B737 AC motor pump upgrade

Fuel and motion control division

End-turn shielding

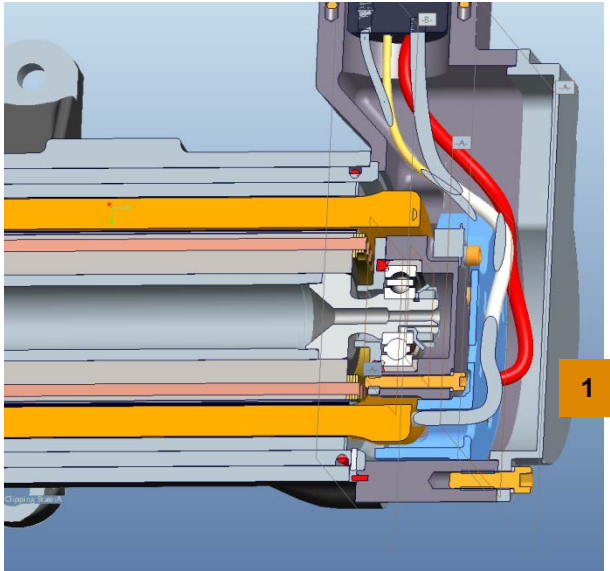
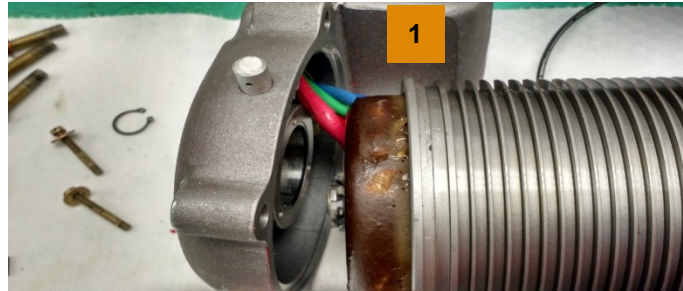
1 New insulator providing end turn shielding

1 No shielding in the incumbent configuration

Ensure thermal and electrical isolation by incorporating two high-temperature non-conductive shields between the structure and the stator windings.

Configuration updates

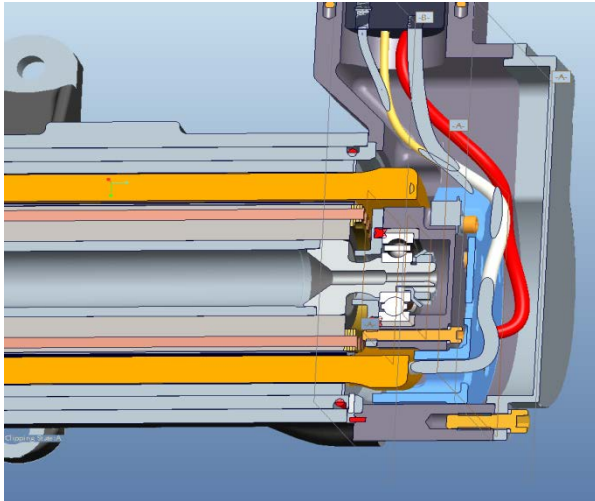
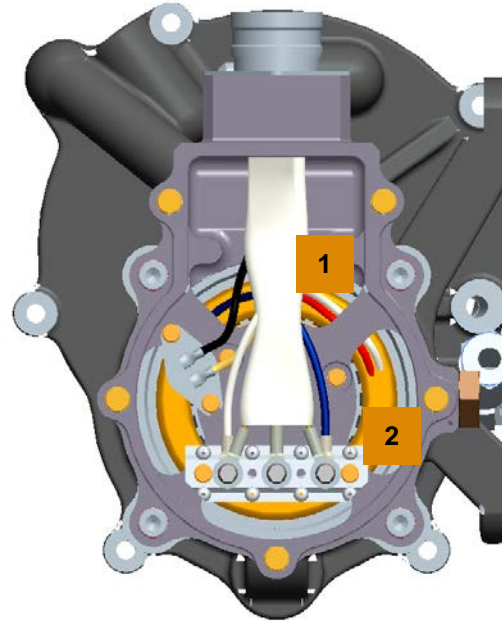
Validation of the design with separation of lead wires has demonstrated inconsistency (pass/fail) during 2 phase testing. Time to failure is too large and the external temperature exceeds the limit of 392°F

- 1 Incorporation of “Fuse Link” device that provides protection to the motor by failing to an open circuit during extended high current (90 amps ~60 seconds) events
- 2 Terminal strip – provides connection between stator leads and “Fuse Link”

Electrical isolation and phase lead support

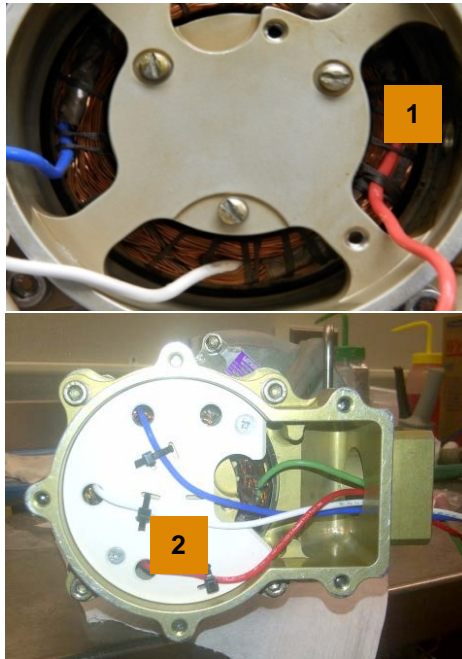
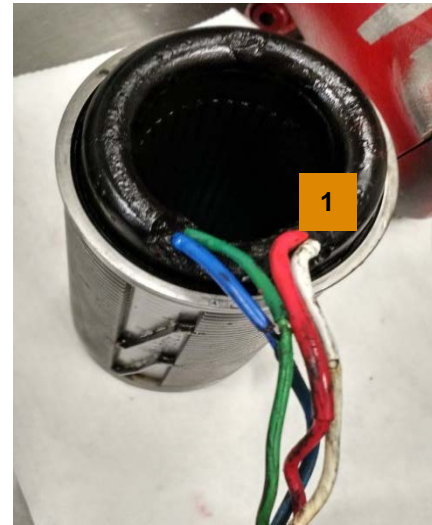
- 1 90 deg. phase lead separation
- 2 New Insulator providing phase lead isolation and support

- 1 No phase lead spacing, isolation, or support

Ensure electrical isolation by redesigning the stator, incorporating non-conductive shields, and implementing improved wire routing.

Ensure isolation after the phase lead is severed from the stator end-windings by incorporating wiring supports into the non-conductive shield.
